**SUBJECT:** SUB20-002, Douglas 234 Filing 6 – Minor Development Plat Review Comments v3

# DOUGLAS 234 FILING 6

## A REPLAT OF LOT 1, BLOCK 10, DOUGLAS 234 FILING NO. 1, BEING LOCATED IN SOUTHEAST QUARTER OF SECTION 29, TOWNSHIP 6 SOUTH, RANGE 66 WEST 6TH P.M. TOWN OF PARKER, COUNTY OF DOUGLAS, STATE OF COLORADO

# DOUGLAS 234, FILING NO.6

**SHEET 2 OF 2**

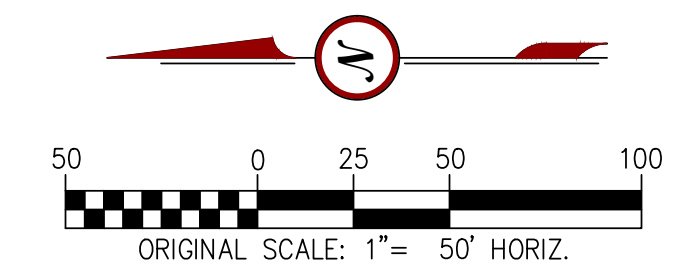
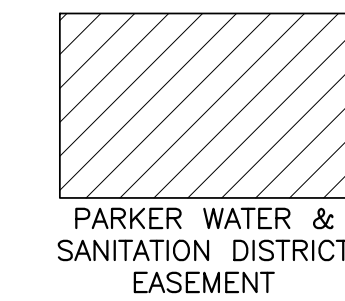
The plat cannot be recorded with any blanks. The easements must be required prior to the MDP being recorded. Please provide information to staff on how timing for these blanks will be satisfied.

Remove all +/- from the entire plat. Exact values need to be provided. This plat will not be scheduled for public hearings if there are any +/- shown on the plat.

Please provide additional clarification indicating where Tract B boundaries are.

Include the reception number.

WE WILL RECORD THE PLAT AND EASEMENT AGREEMENTS SIMULTANEOUSLY, WE INTEND TO WRITE THE NUMBERS IN ON THE PLAT PRIOR TO RECORDATION. WE ACKNOWLEDGE THE PLAT WILL NOT BE RECORDED WITHOUT THESE BLANKS FILLED IN

## LANDSCAPE NOTES & DETAILS

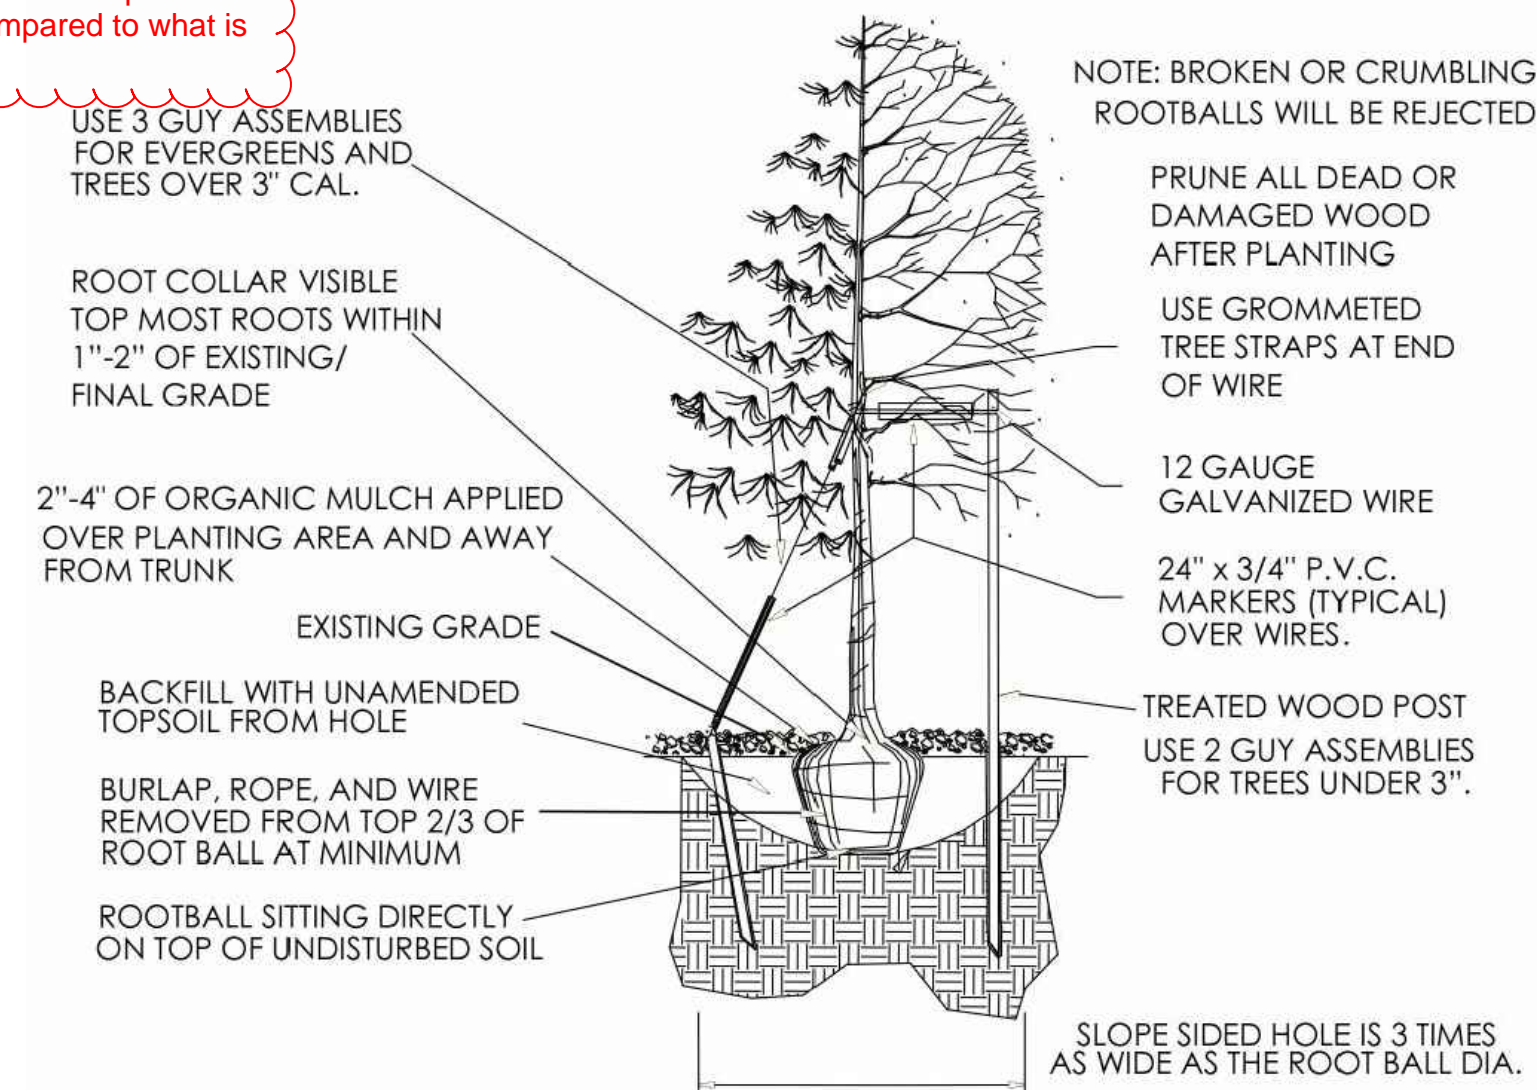
All landscaping needs to be shown in the quantity table. The table shows only 89 trees, however the buffer and street scape tables show a total of 125 trees. Please be sure all quantities for all plant types are correct in the table compared to what is being provided.
